FirstEnergy Nuclear Operating Company

March 14, 2002
PY-CEI/NRR-2614L

Perry Nuclear Power Plant
Docket No. 50-440
License Amendment Request Pursuant to 10 CFR 50.90: Inclined Fuel Transfer System (IFTS)

Transfer Tube
(FROM
USAR Figure 9.1-19)

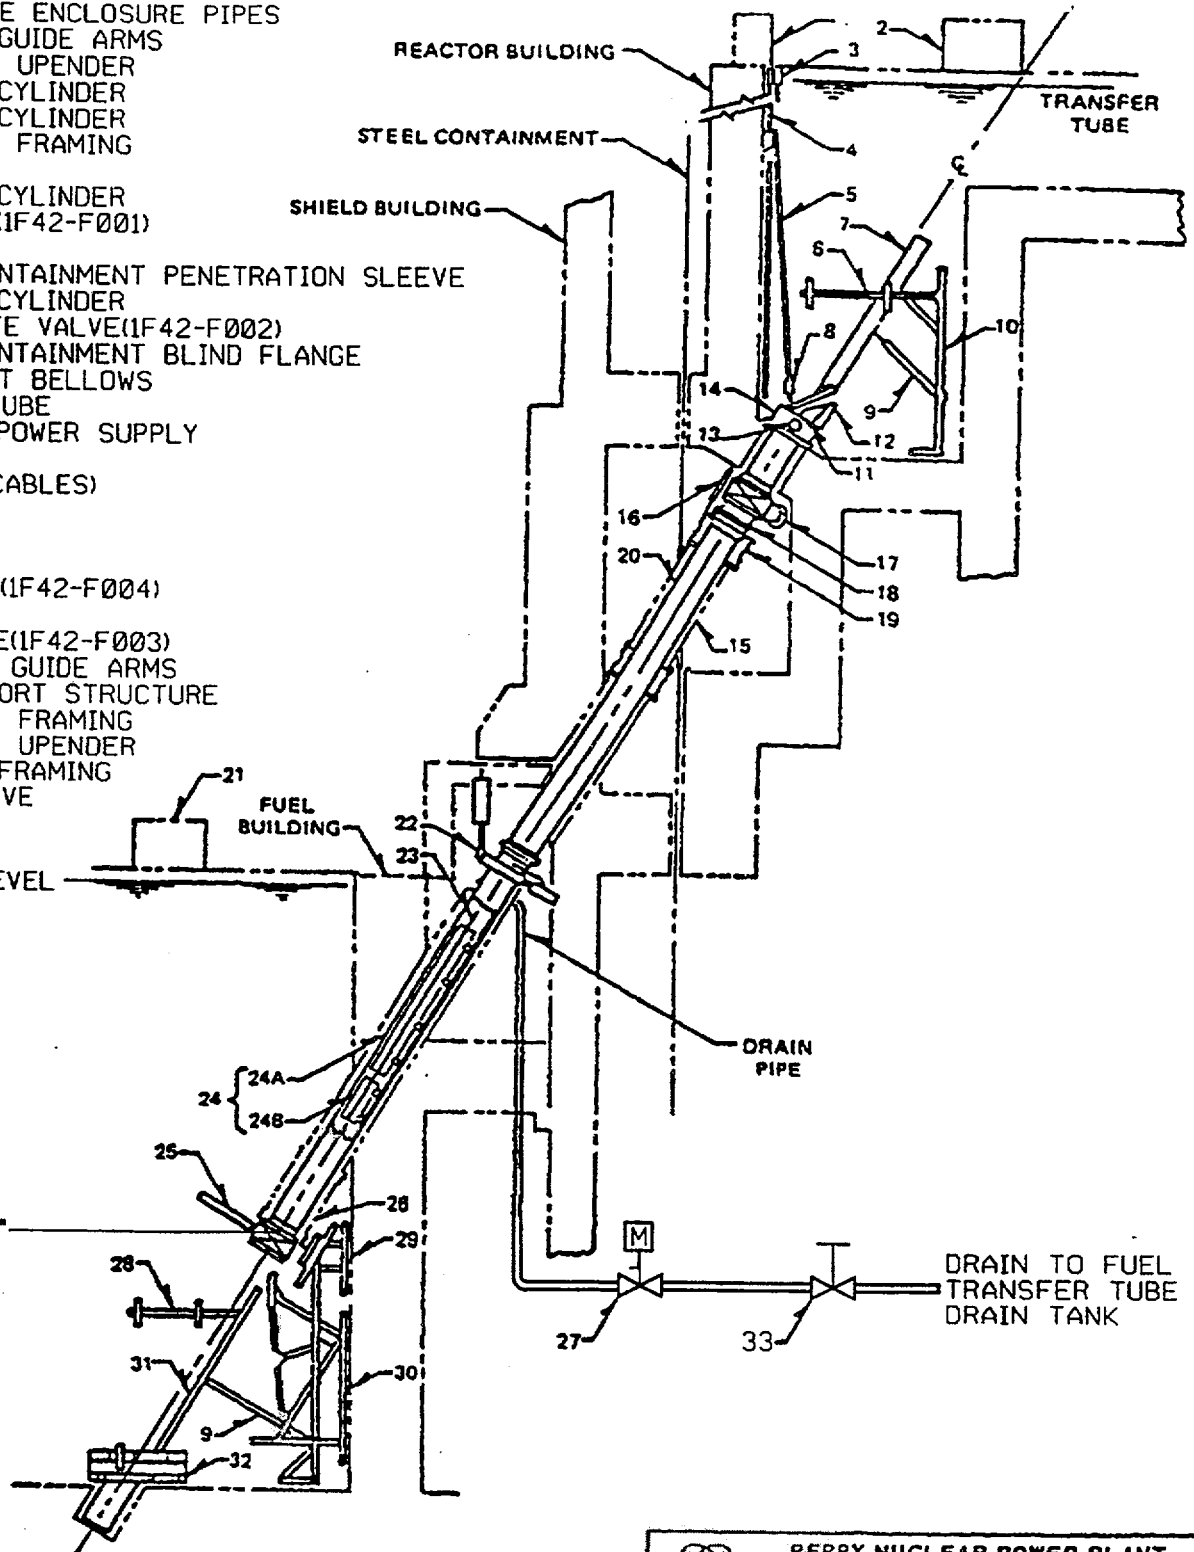
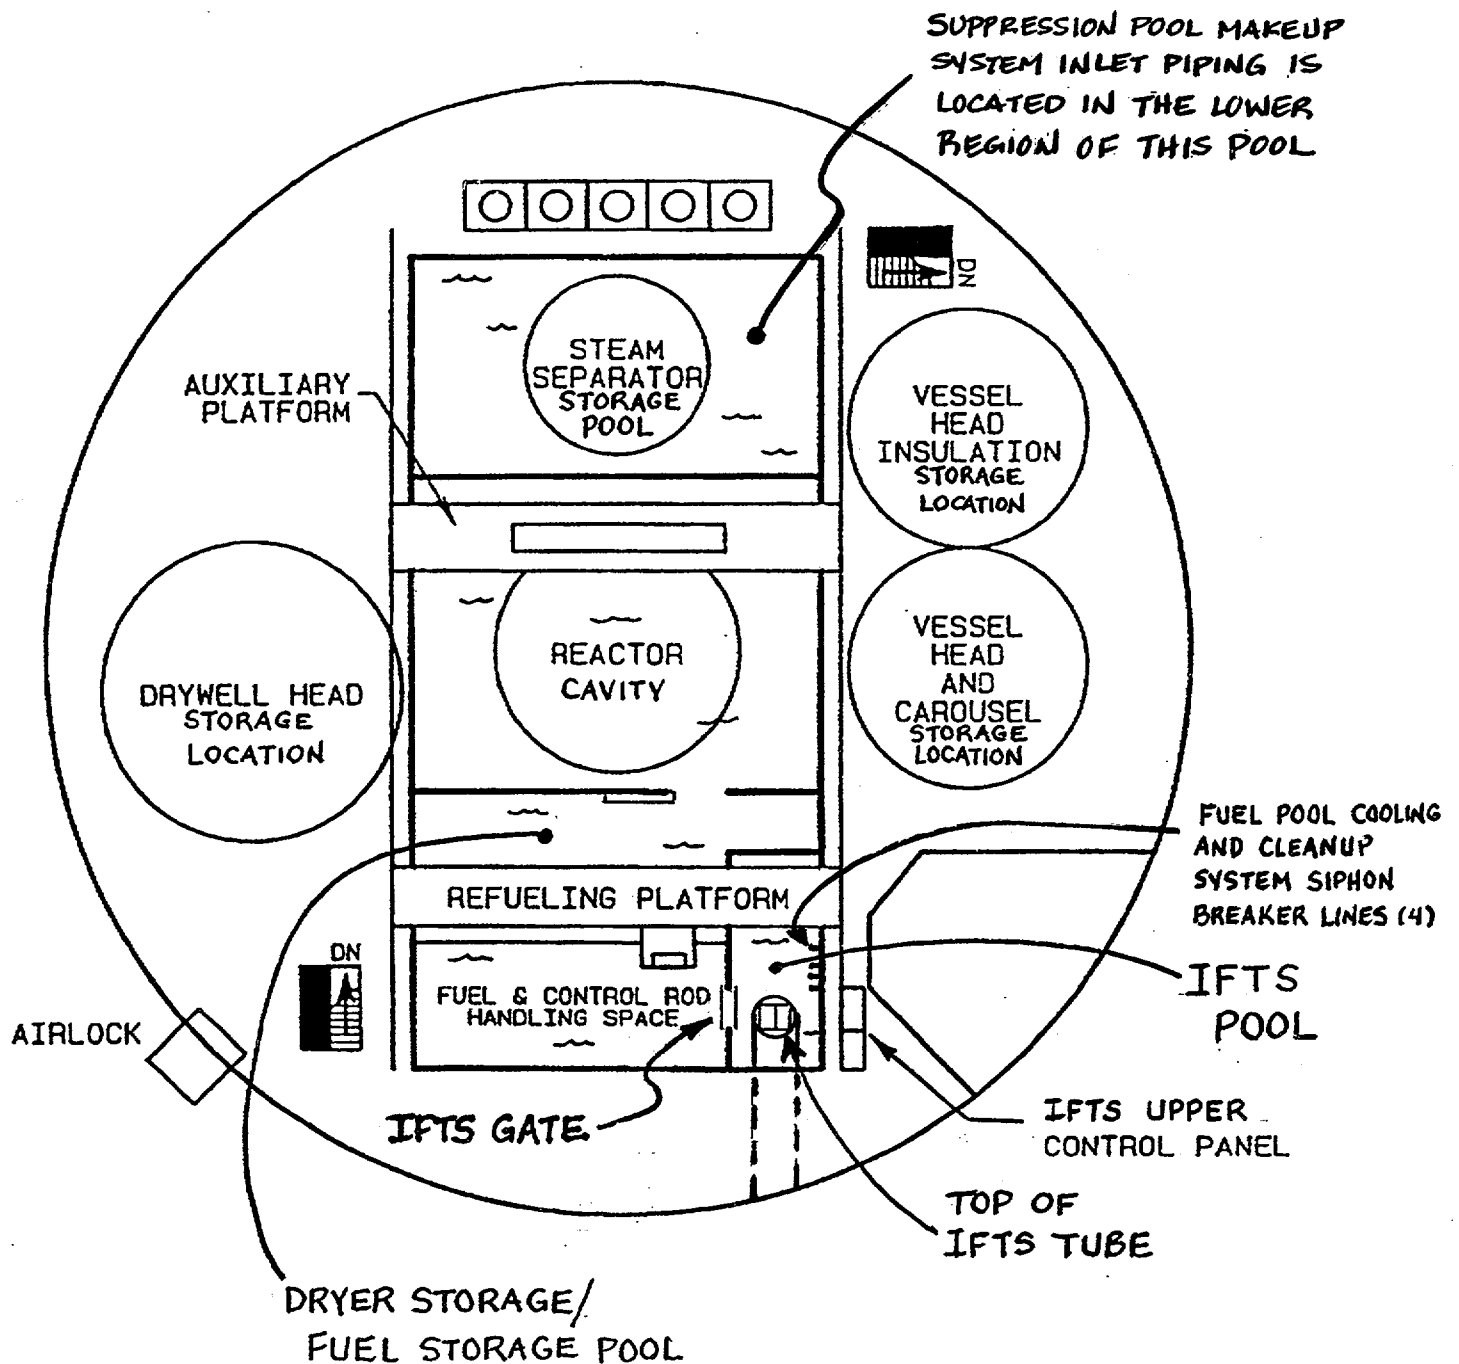
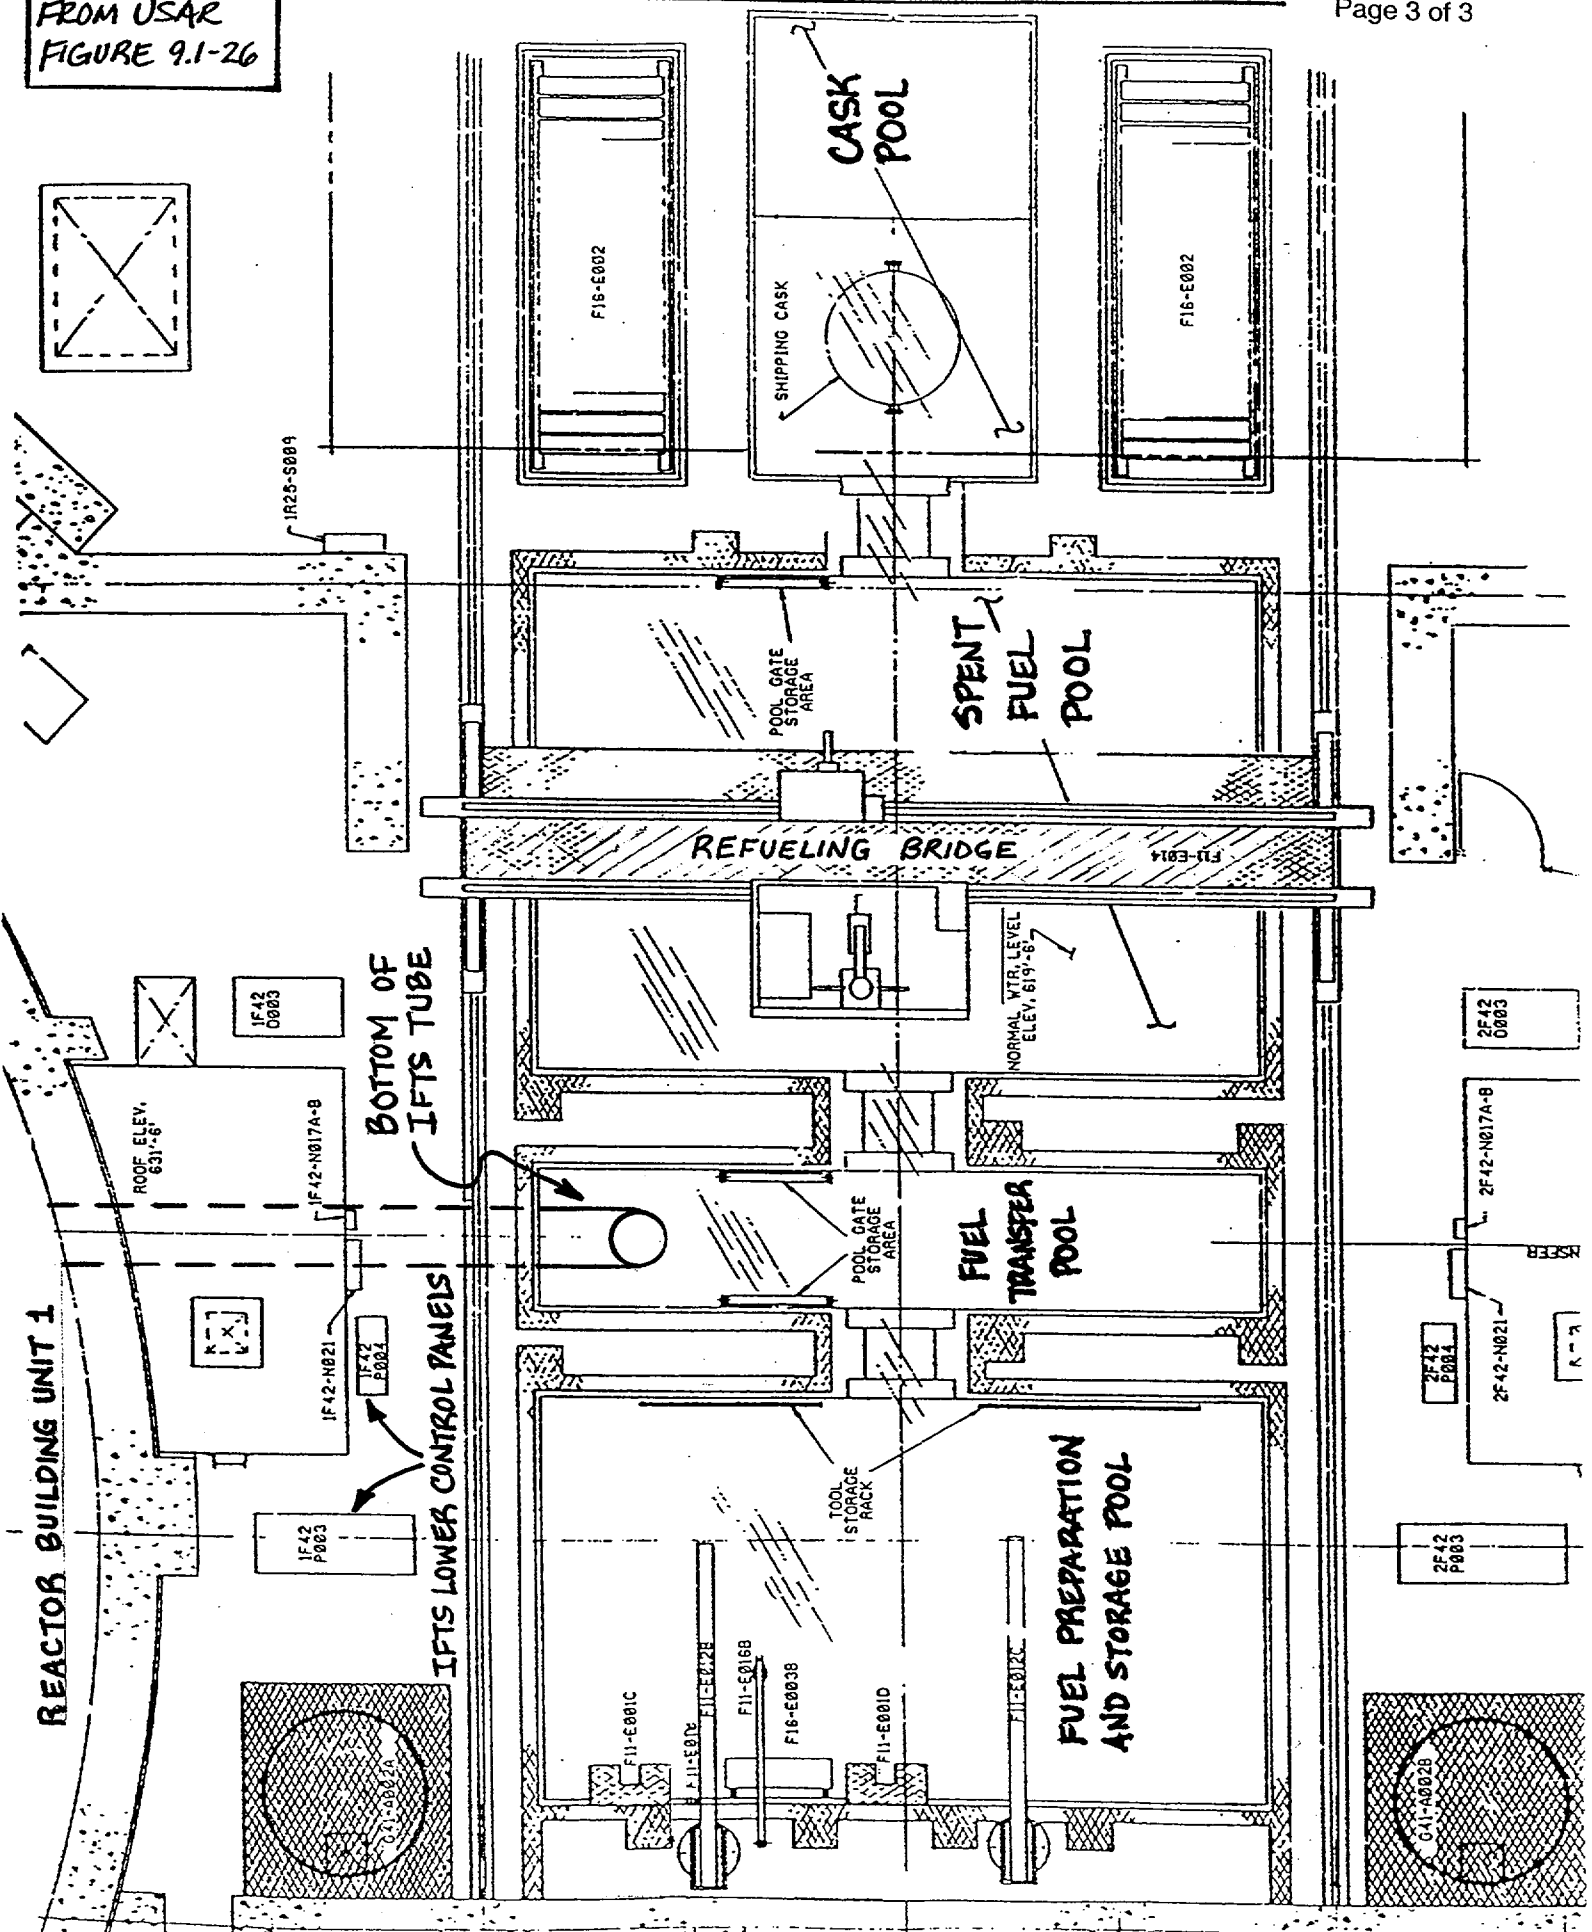
The lines that lead into the IFTS pool are 1" siphon breaker lines (reference page 2 of Attachment 3). These lines come off of the supply lines into the Reactor Cavity, the Dryer Storage/Fuel Storage pool and the Steam Separator Storage pool. The function of the four 1" siphon breaker lines is to break the vacuum of the Fuel Pool Cooling and Cleanup system supply water piping in the event of a supply pipe failure. Should the supply piping fail at a low elevation outside of the pool, the pump side of the break would discharge to the floor. However the poolside of the break, because of its low elevation would cause reverse flow or siphon of the pool volume through the normal supply to the pool. The safety related, seismic, siphon breaker lines serve to break this vacuum and minimize pool inventory loss, thus providing protection of the SPMU inventory.

The siphon breaker lines terminate in the upper Containment IFTS pool below the required SPMU water level. During a design basis LOCA, with a postulated component failure or a receipt of a spurious opening signal for one of the non-safety, non-seismic IFTS components, the upper IFTS pool would drain and as a result, the other upper Containment pools would potentially drain into the IFTS pool via the siphon breaker lines. This would lower the SPMU's available water inventory and may adversely impact its design function. To address this issue, a modification will be completed to extend the elevation of the affected Fuel Pool Cooling and Cleanup system siphon breaker lines that discharge to the upper IFTS Containment pool to above the minimum required SPMU level. This modification will be completed before the proposed LAR is implemented.

3. A modification will be completed to extend the elevation of the affected Fuel Pool Cooling and Cleanup system siphon breaker lines that discharge to the upper IFTS Containment pool to above the minimum required SPMU level. This modification will be completed before the proposed LAR is implemented.
